**D14 Academic Building**

**Access Report  
prepared for UNSW  
Sydney  
Final v3**

**3 April 2019**

Figure 1: Extract (not-to-scale) from drawing ADDA00001. North is up the page, and High Street runs from left to right at the very top of the image.

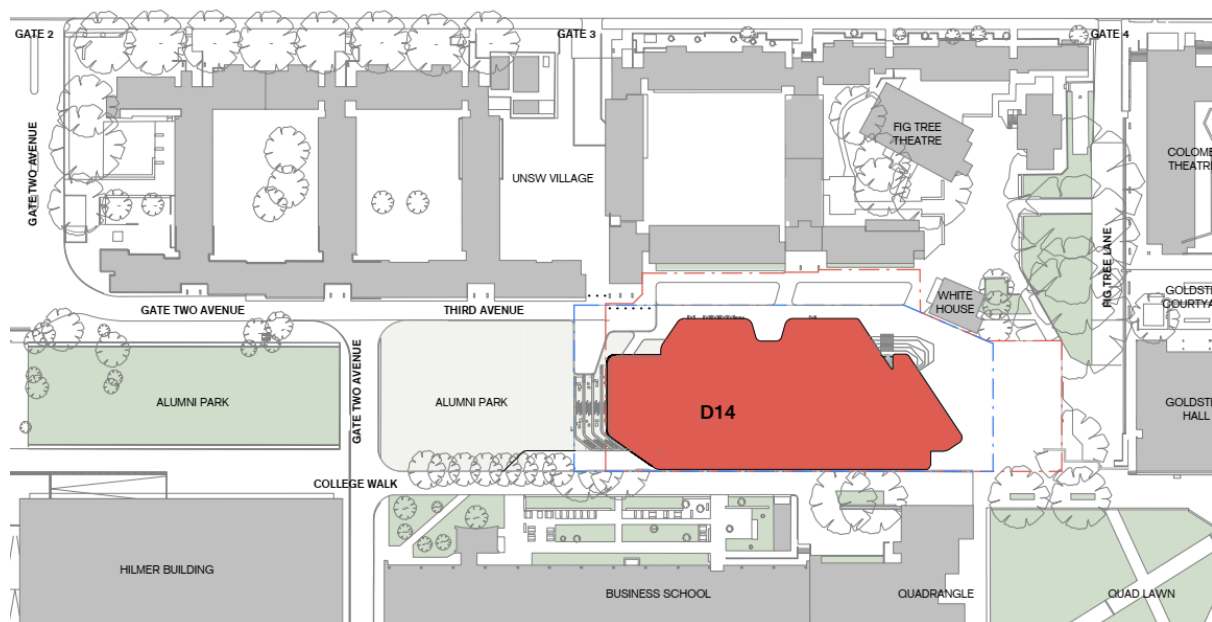
It is noted that there will be a new truck service bay on Third Avenue on Ground Level in the north-west sector of the building, as shown on drawing ADDA20000. The truck service bay will be on-grade with the adjacent pedestrian-only footpath. The vehicular path of travel will be designated as a 'shared zone'.

Insofar as trucks are sharing the same space as pedestrians, the trucks will pose a safety hazard for people with a disability. This is given that people with a disability may have not have the same capacity to detect an oncoming vehicle or, if they do detect an oncoming vehicle, they may not have the capacity to avoid that vehicle in time.

To address this safety risk for people with a disability, the area will require a package of safety measures. This could include, but would not be limited to, the following: restricted hours of use for vehicles, speed limits, contrasting flooring, bollards, and clear signage. Alternatively, the use of a kerb-and-gutter roadway would be advisable in lieu of a shared zone. This area will be appropriately addressed during the design development phase.

Figure 3: Not-to-scale representation of the proposed new landscaping on Level 1 of the subject building.

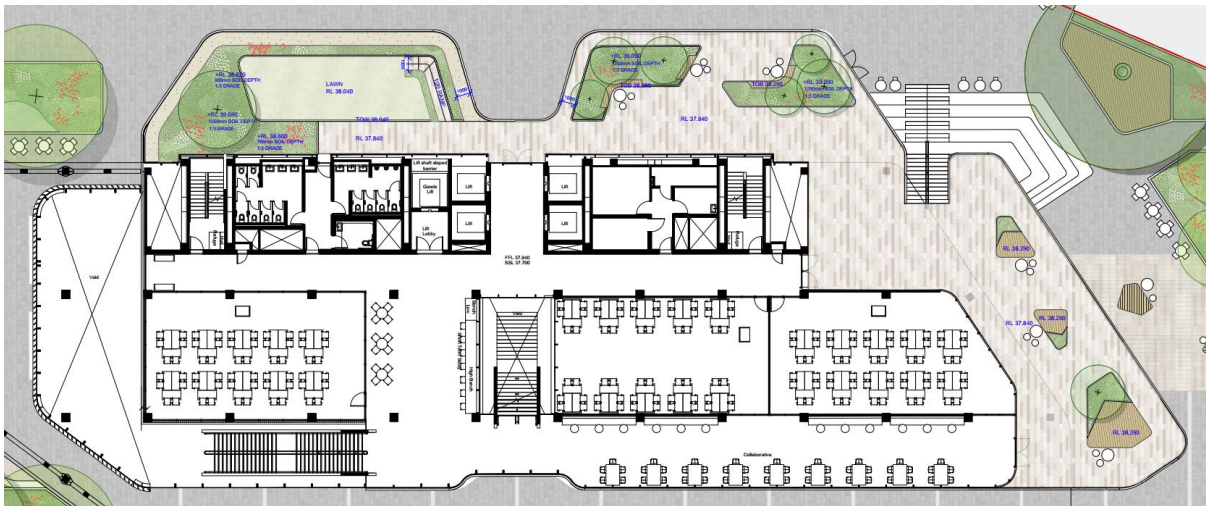
The RtS design will continue to provide continuous accessible paths of travel for people with a disability from the internal areas of the subject building on Level 1 to the external terrace.

The RtS design includes a new raised platform for common use at the far western side of the terrace. There will be a new 1:20 walkway that will run up to the raised platform. The 1:20 walkway will be detailed to meet AS1428.1 during design development phase.

The finished flooring of the raised platform is nominated as turf. The provision of a reasonable proportion of hardstand flooring will be achieved during design development phase to allow wheelchair users the opportunity to enjoy that space.
